# Staff Report

**Re:** PLNHLC2021-00967 New Construction and PLNHLC2021-00966 Special Exception at 237 N. Almond Street

## NEW CONSTRUCTION AND SPECIAL EXCEPTIONS IN A HISTORIC DISTRICT

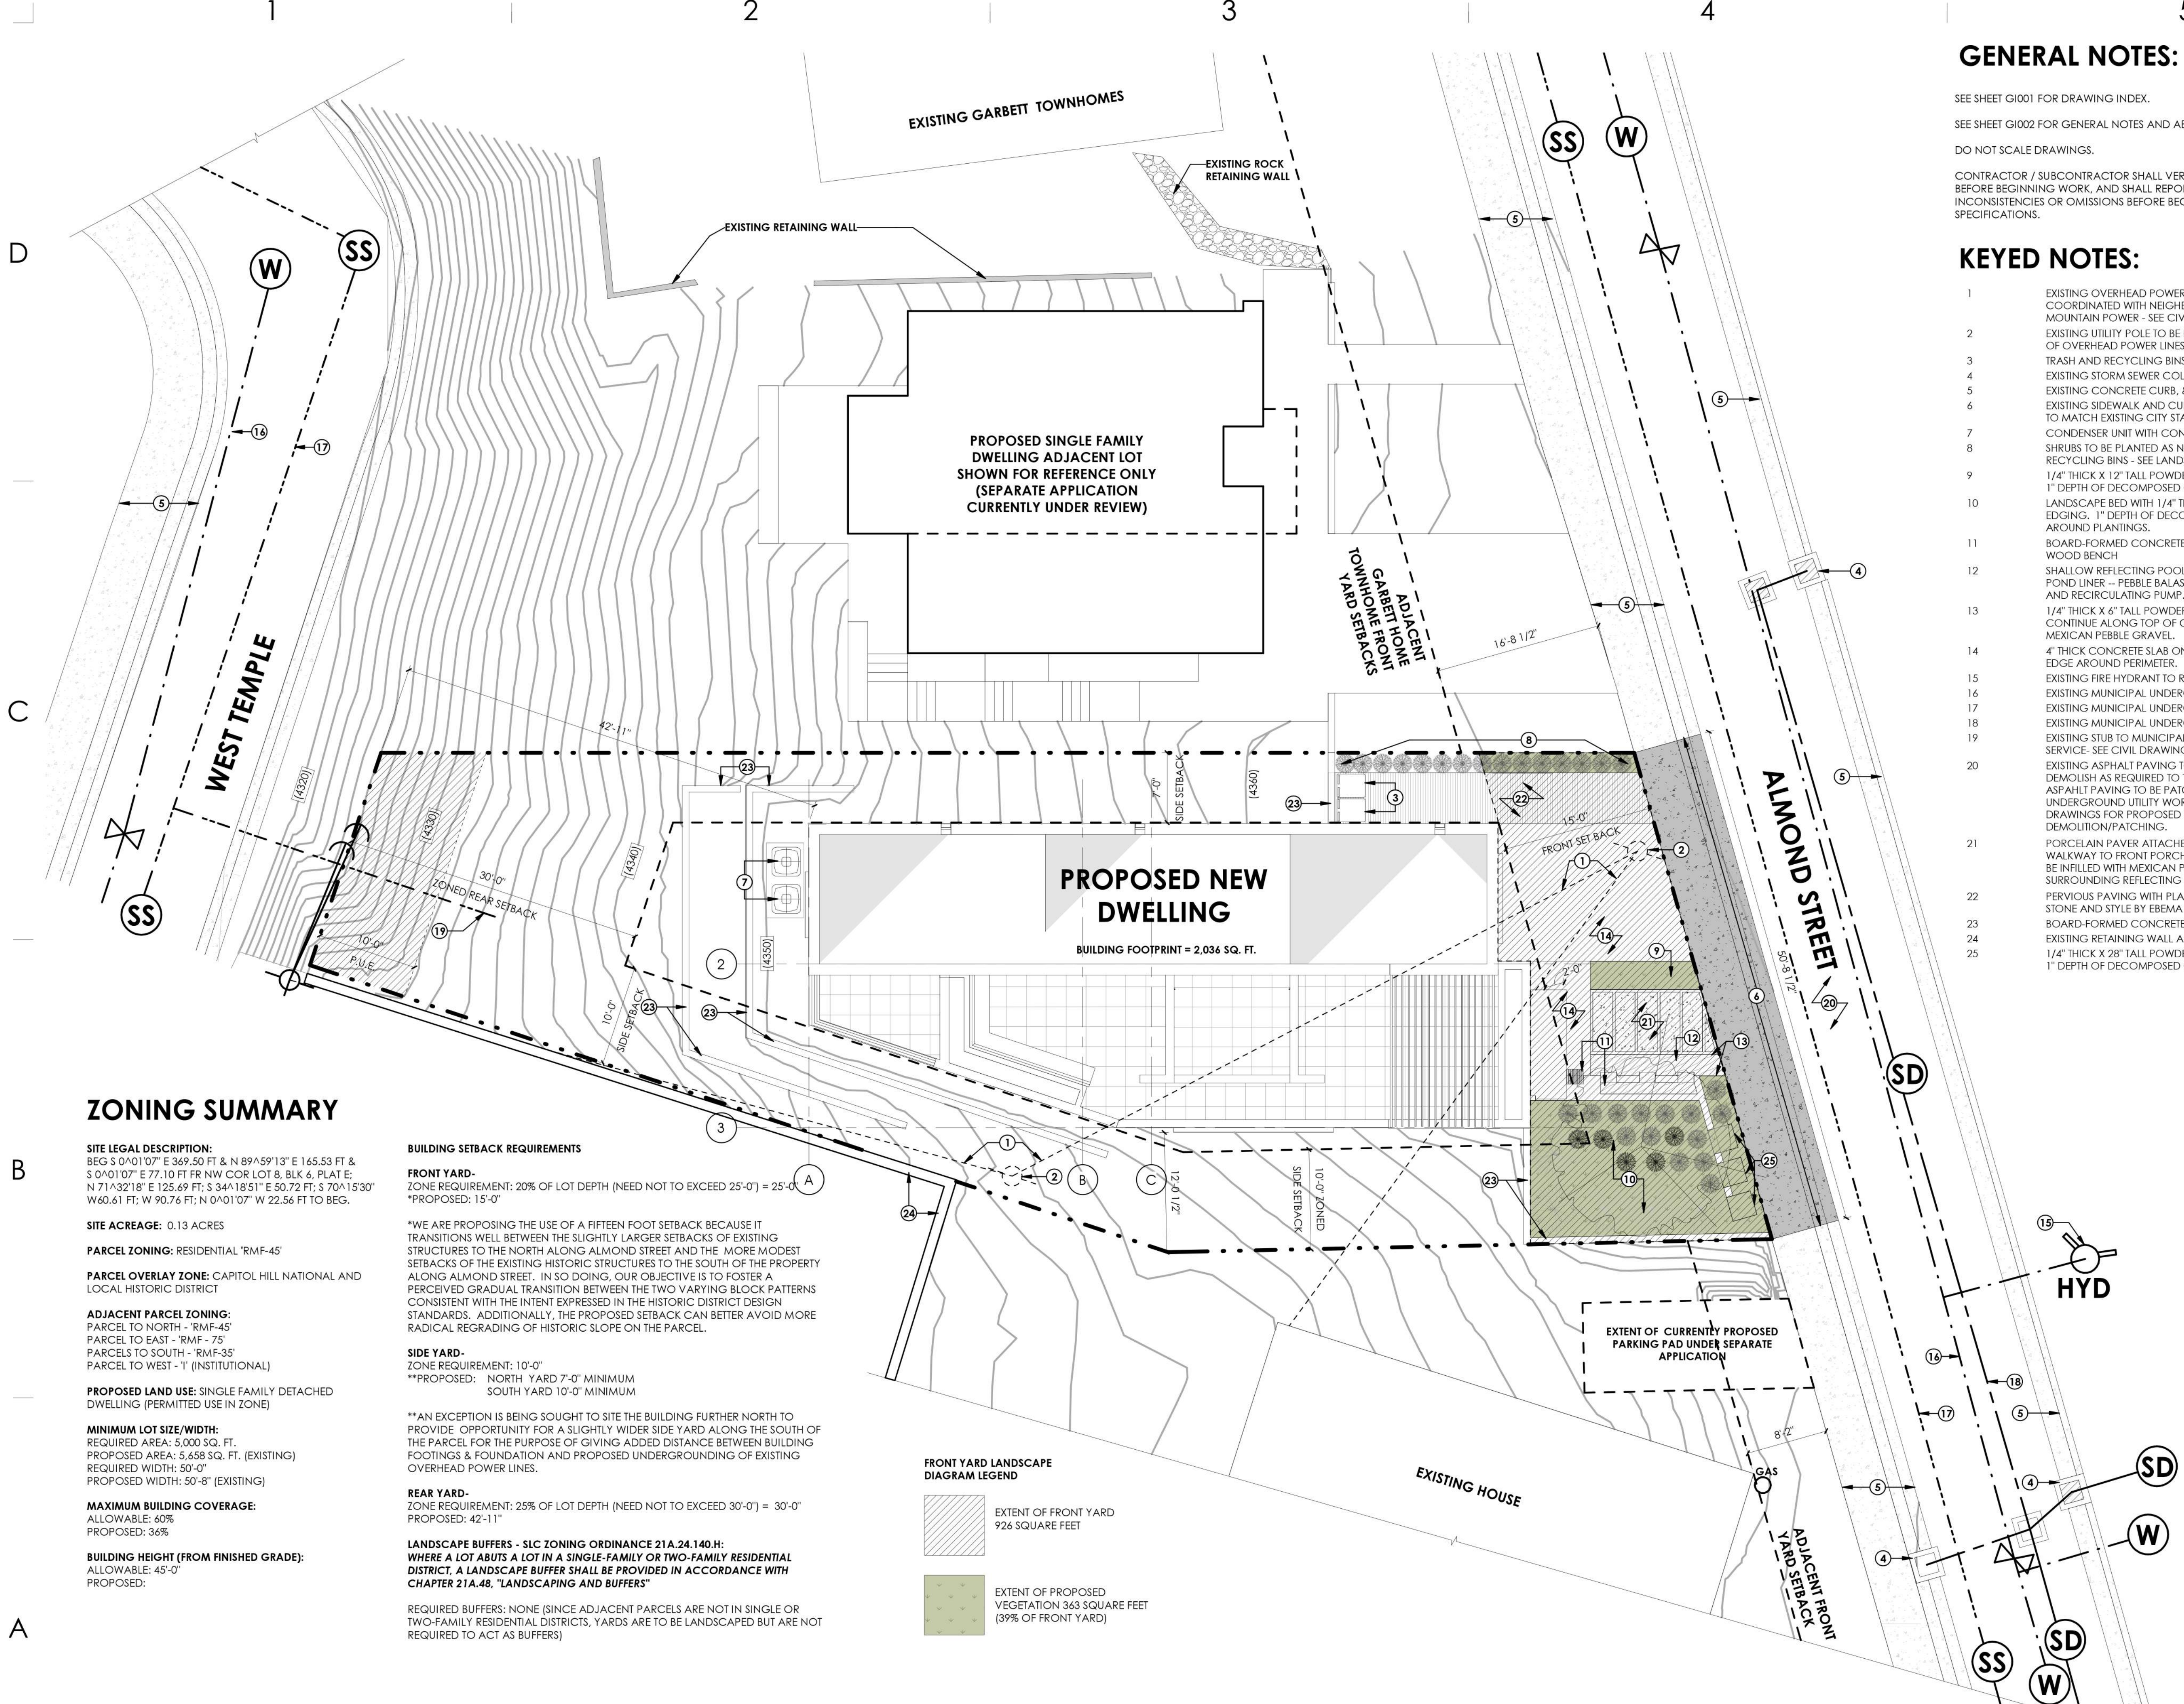
*I don't see any critical issues from Transportation. The tandem parking is allowed per an interpretation by Planning (email on September 25, 2014). The dimensions of the tandem parking spaces were not shown on the plans and the clear area needs to be at least 9.25 feet wide by 35 feet long to accommodate two parking stalls.*

Please refer to provided dimensions on the Level 1 floor plan. As shown, the interior dimensions for the tandem parking garage (13'-0 1/2" wide x 40'-7") satisfy the minimums outlined in the comment above. Please let us know if there are any further concerns to resolve upon review.

**A1 ARCHITECTURAL SITE PLAN**  
 1/8" = 1'-0"

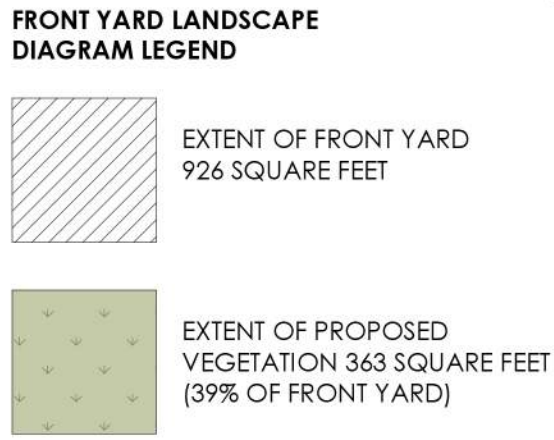
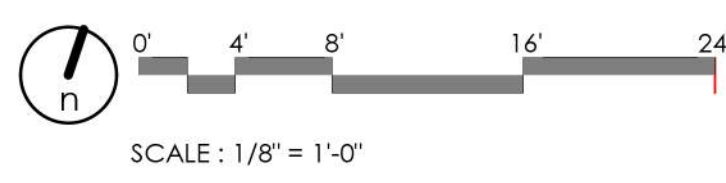
- Front yard parking is not permitted, and cars cannot be parked in the portion of the driveway that is in the front yard. Please remove the car from the drawing. (Table 21A.36.020B)

Comment has been noted and drawings updated accordingly - please refer to updated site plan with dashed car removed.

**C1 EAST ELEVATION**  
1/8" = 1'-0"

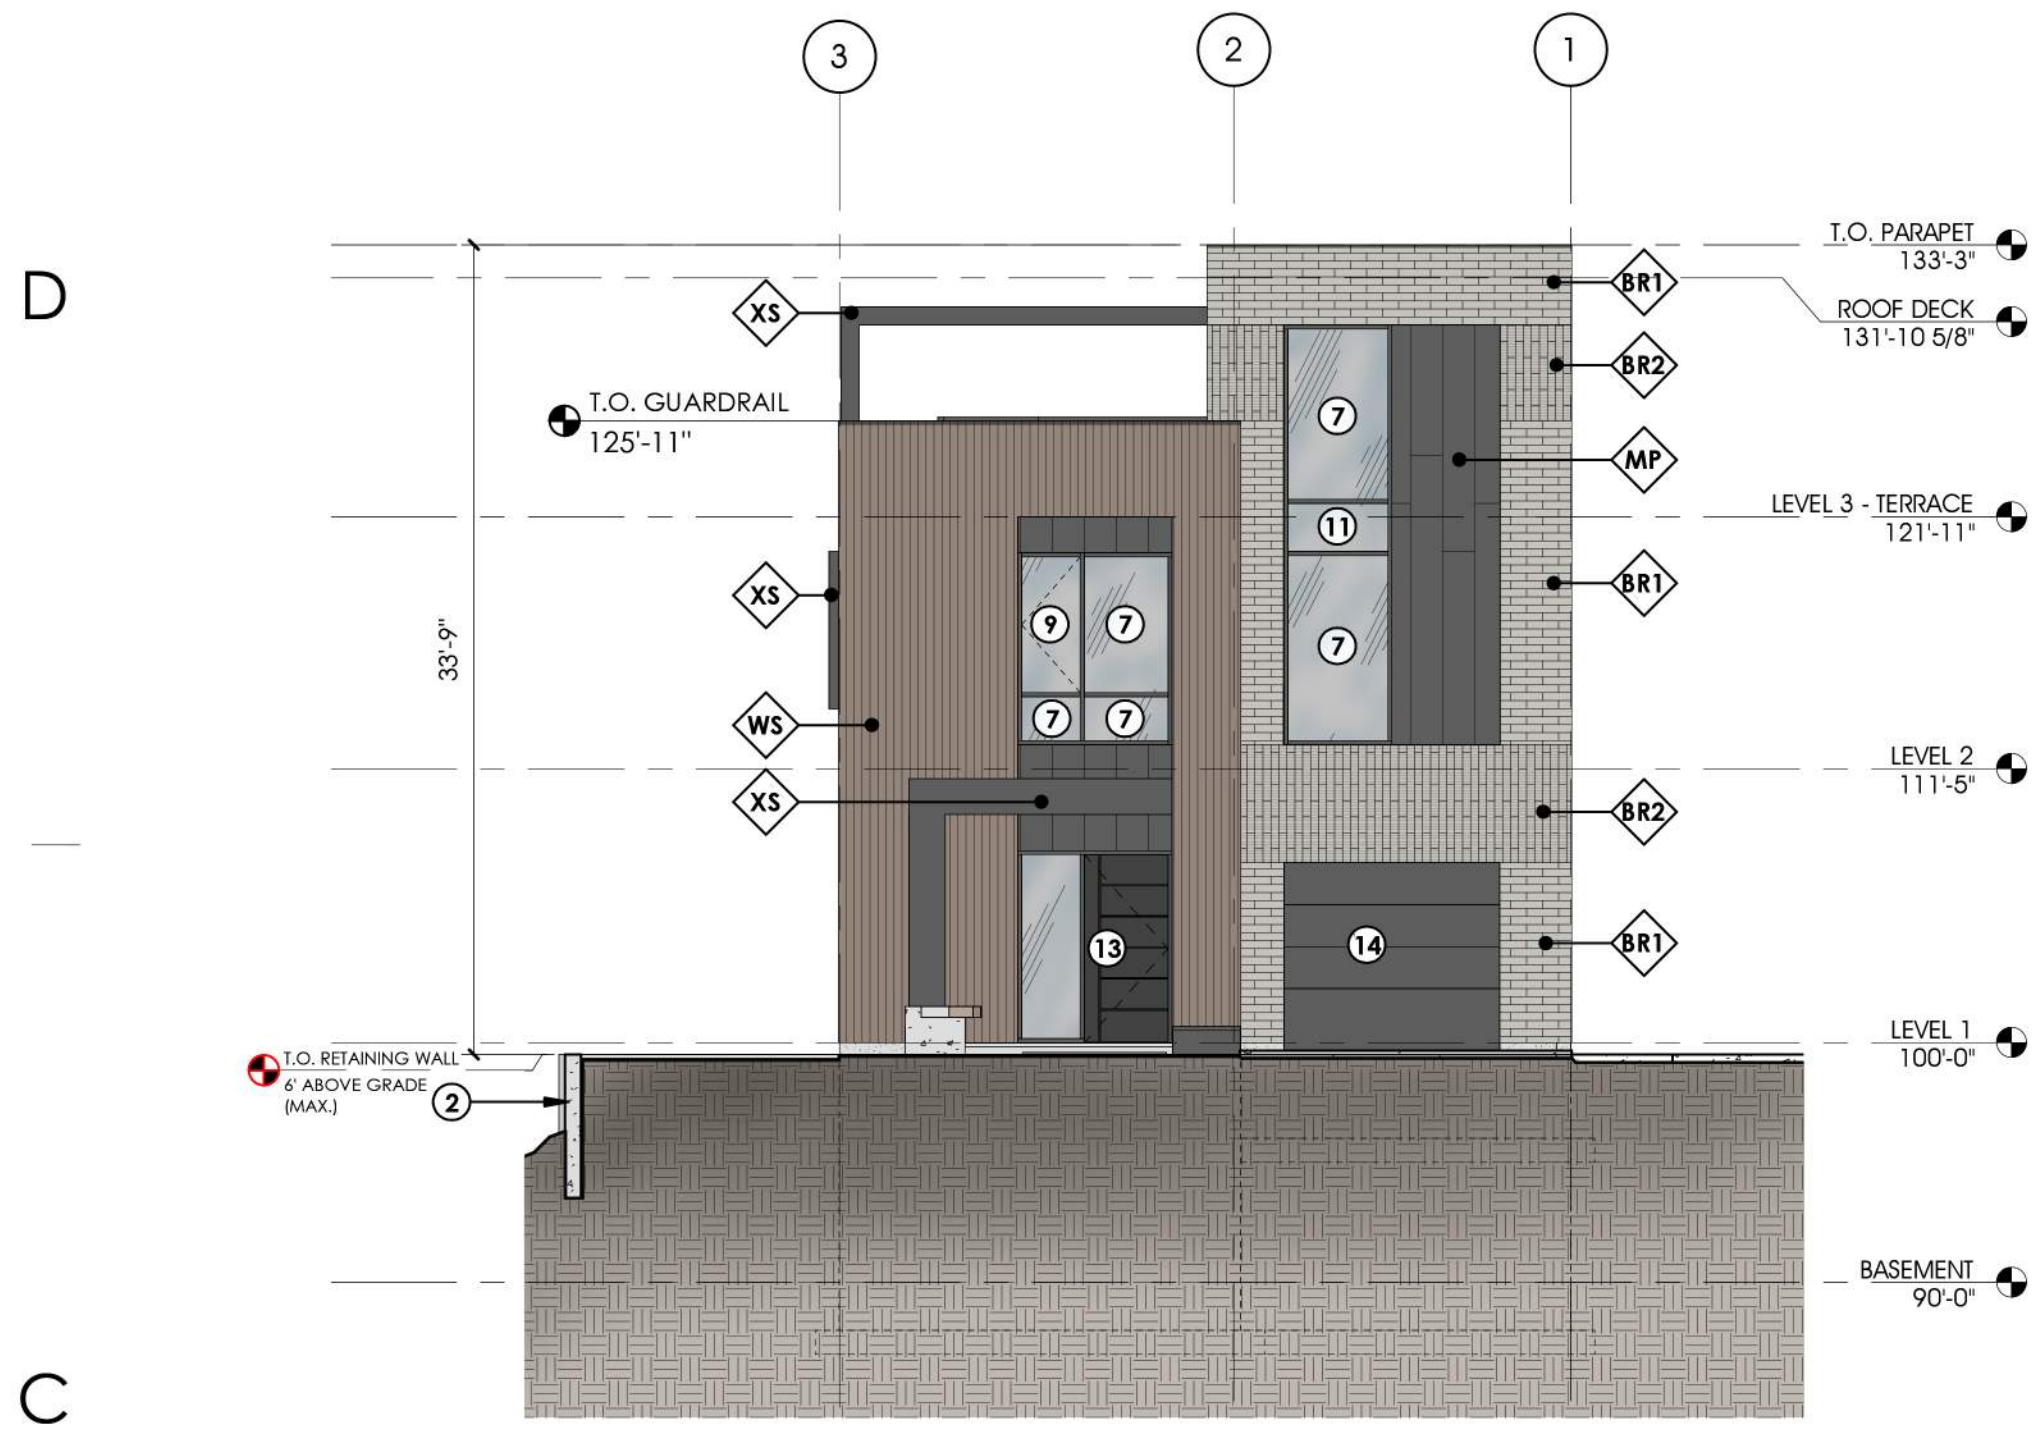
*- Proposed residence is taller than other single-family residences on the street. The vertical wood siding on the front façade emphasizes this height. Consider modifying it with horizontal wood siding or provide a change in the orientation similar to the brick on the taller mass to the north (21A.34.020.H.5).*

The concern in siding orientation is noted -- applicants would still ultimately prefer to have the siding installed vertically as it yields a more elegant articulation of the building massing. To address staff's concerns, applicants are proposing revisions to the entry canopy design as well as more varied heights of the landscape walls and planting beds on the front yard site improvements. Applicants would propose that these changes help to break up the continuity of the vertical siding orientation suitably enough so as to not exacerbate perceived height increase from principal facades for other single family residences on the block. As a matter of note, it is the applicant's design intent for the wood siding to be installed as a rain screen application to allow for a drainage plane and ventilation to occur between the wood siding and the continuous layer of rigid insulation. Doing so allows for any water infiltration which may occur over time to drain free and for siding to avoid instances of rot/ degradation (further reinforcing the sidings use as a durable material). Staffs proposal for breaking up the in orientation similar to the masonry on the northern mass of the residence would ultimately prove technically infeasible because the required furring strip configuration for vertical and horizontal siding installations differ and wouldn't allow for these to be flashed and installed in the same vertical wall plane.

**A3 NORTH ELEVATION**  
1/8" = 1'-0"

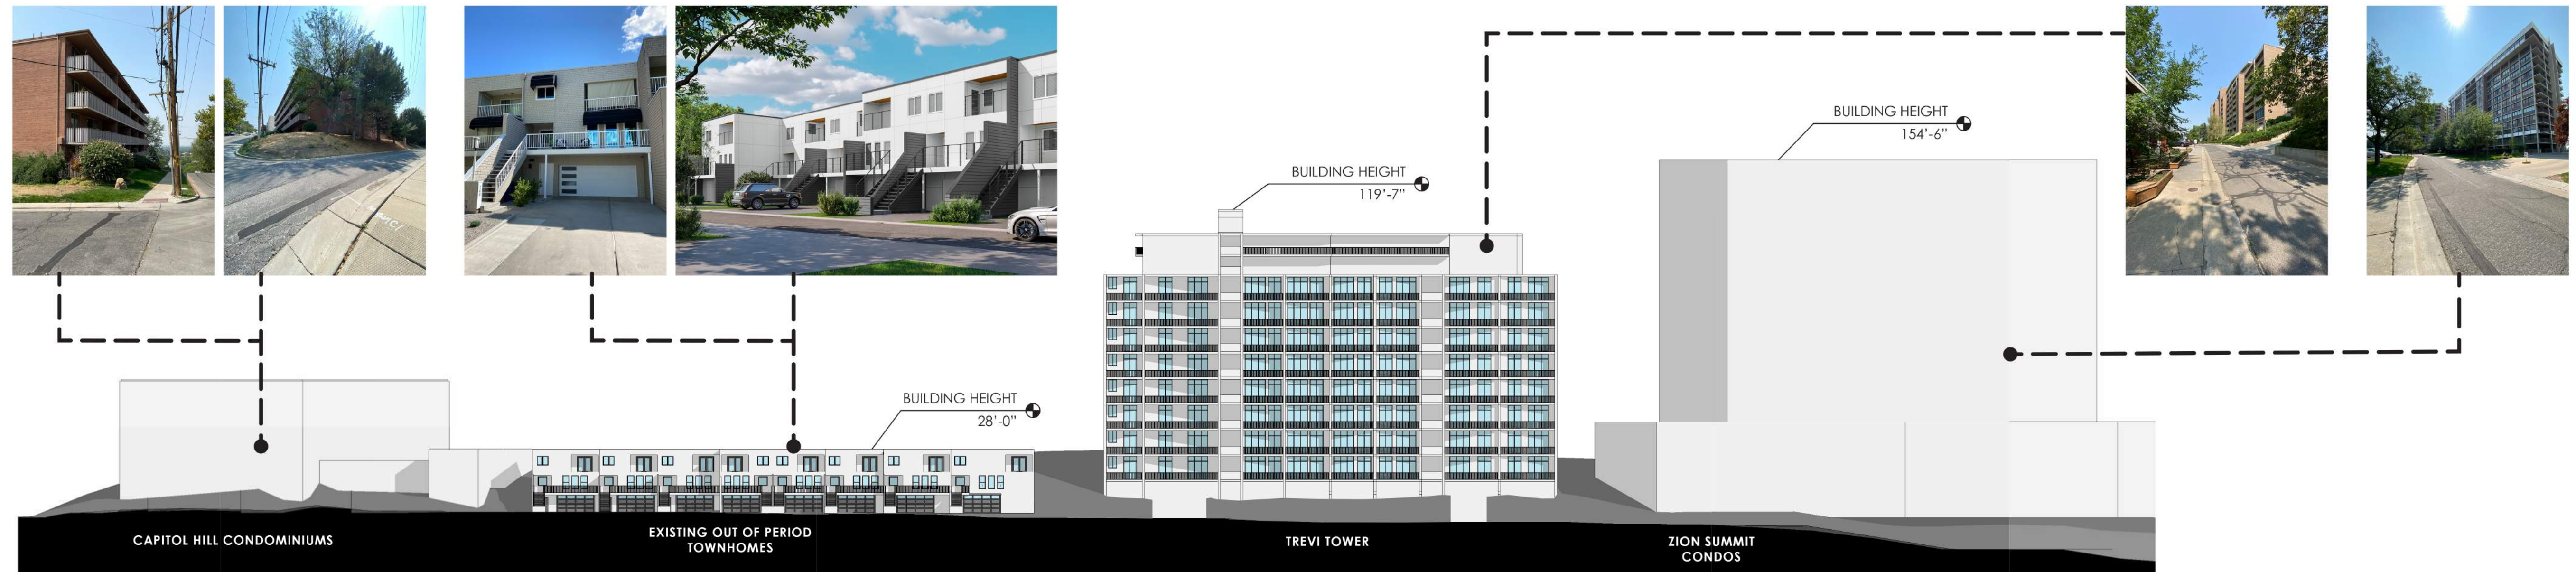
*- Consider modifications to the north façade. The absence of windows and the proposed materials give it a commercial appearance. Additionally, while it is not as visible as the front façade, and there is a change in brick type and the presence of the metal panels, this elevation is not consistent with the solid-to-void ratio common in the district (21A.34.020.H.5).*

To help soften some of the perceived/noted concerns about the elevation feeling too commercial, applicants have proposed that a portion of the metal panel system be replaced with wood siding. It is of note that the proposed floor plan is predominantly comprised of private spaces (i.e. bathrooms/showers, closets, etc) or utilitarian spaces (i.e.

tandem garage) along the north facade, which would not be well-suited to have increased percentages of fenestration that would provide a more vertical window proportion. The arrangement of spaces is intended to allow for greater efficiency of plumbing lines and a more consolidated use of more regularly occupied spaces to take advantage of access to more robust/effective daylighting presented by southern light. Increases in fenestration to windows currently proposed would also further limit the available amount of continuous wall sheathing surface intended to provide structural sheer value for the residence. The solid to void ratios within the district for side elevations vary widely across the district especially with regard to period/out of period homes, but it would seem that the commission/staff have generally allowed for fenestration to respond to the interior spatial uses which the fenestration serves. The proposed ratio of glazing to solid wall on the current design is fairly consistent with that of other new construction projects approved/built along Almond Street as well as those completed on Vine Street within the last five years.
